CONNECTION ASSESSMENT & APPROVAL PROCESS

Preliminary Assessment Report Lake Erie Interconnection Project

CAA ID 2000-017

Long Term Forecasts & Assessments Department

Figure 1 - Preliminary Simplified One-line of HVDC Transmission System

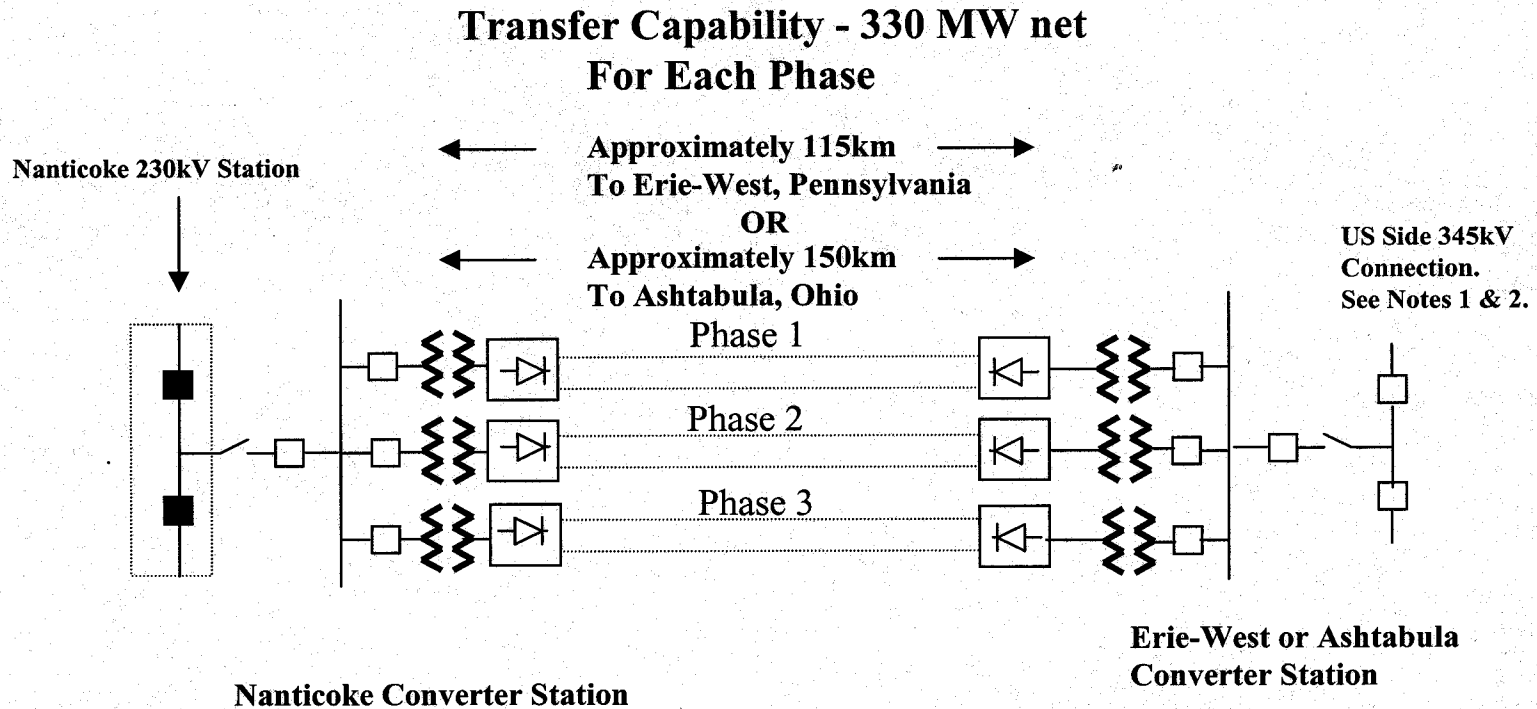
The proposed connection arrangement that was submitted with the Preliminary Assessment application is shown in Figure 1. In the initial stage a single 330 MW HVdc link will be connected via a 230 kV in-line breaker onto a *new diameter* at Nanticoke TGS. In the ultimate configuration a total of three HVdc bipoles are proposed to be connected in parallel to Nanticoke TGS switchyard via one single in-line breaker. Figure 2 shows the proposed ultimate arrangement. It should be noted that under this arrangement the entire interconnection would be lost under conditions of one breaker outage.

To eliminate the possibility of losing the entire interconnection due to one breaker open condition, the IMO proposes an alternative connection arrangement as shown in Figure 3.
